TECHNICAL BULLETIN

Hood Panel – Difficult To Latch – Revised Latch and Hood Release Lever Guard Introduced – Service Action S448

76-96

MODEL XJS Range 1994 - 1995 MY DATE 11/94

ILLUSTRATION 1

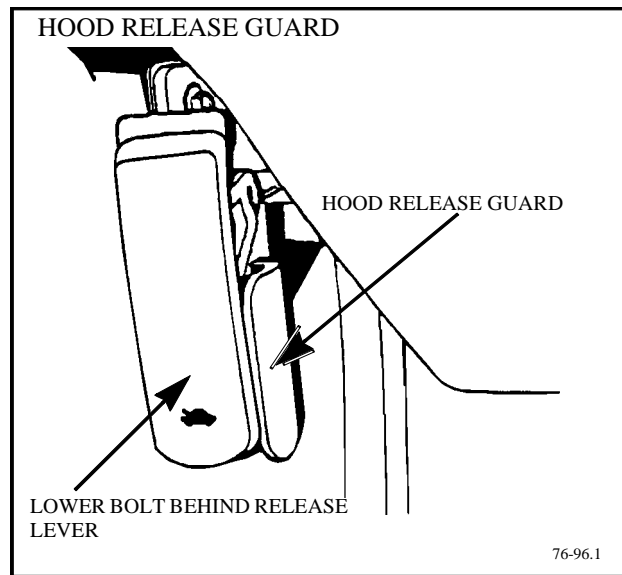
To prevent inadvertent operation of the hood release, a release lever guard was introduced in production at VIN 194776.

1. Remove the lower bolt of the hood release lever.
2. Align the guard as shown in Illustration 1 and replace the lower bolt.

ILLUSTRATION 2

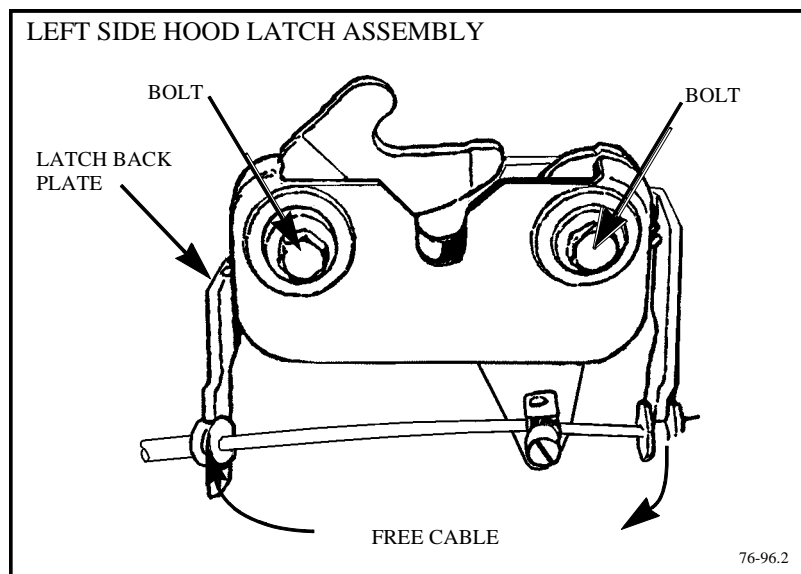
1. Mark the position of both hood latches on the engine compartment bulkhead.
2. Remove the two bolts holding the left side latch assembly to the bulkhead (Illustration 2).
3. Free the release cable from the latch back plate, then remove and discard the back plate.

ILLUSTRATION 3

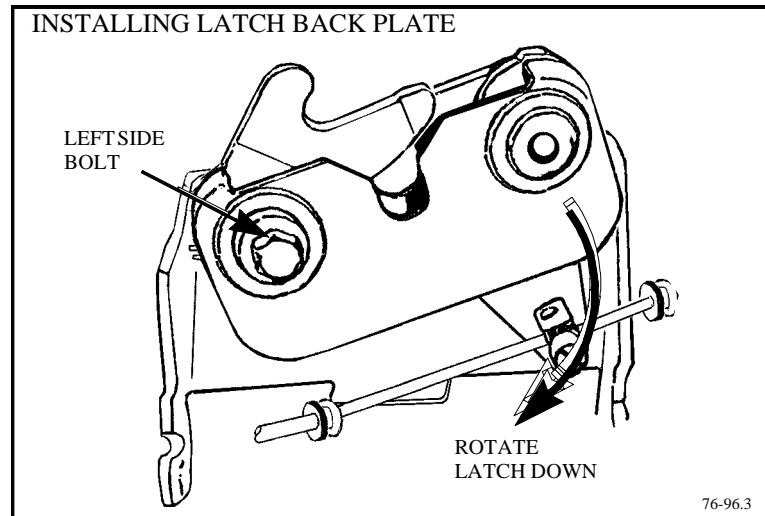
The revised latch back plate accomplishes the following:

- Prevents the latch pawl from going over center
- Increases the pawl return spring pressure to aid hood “pop-up” when the hood is released.

4. Place the new latch back plate behind the latch in the position shown in Illustration 3. Insert the left side bolt through the back plate to use as a pivot.
5. Rotate the right side of the latch down to “wind up” the latch spring and insert the right side bolt.

ILLUSTRATION 4

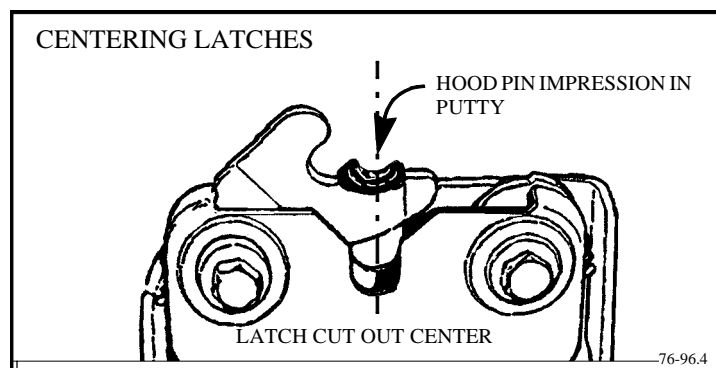
6. Insert the hood release cables into the slots in the latch back plate.
7. Align the latch assembly to the marks on the bulkhead and tighten the mounting bolts.
8. Repeat steps number 2 through 7 for the right side latch assembly.
9. Grease the latch pawl springs and the pivot points on both latches with multipurpose grease.
10. Loosen the release cable clamp bolts on both latches. Pull the cable end of the right latch to remove any cable slack, release the cable. Tighten the right side cable clamp bolt first, then tighten the left hand cable clamp bolt.
11. Place body putty or “dumdum” on both latches as shown in Illustration 4.
12. Move the hood down until both hood pins make impressions in the putty. The hood pin impressions must be in the center of the latch cutouts (Illustration 4). If necessary, move the latch assembly left or right to center the latch cutout to the hood pin.
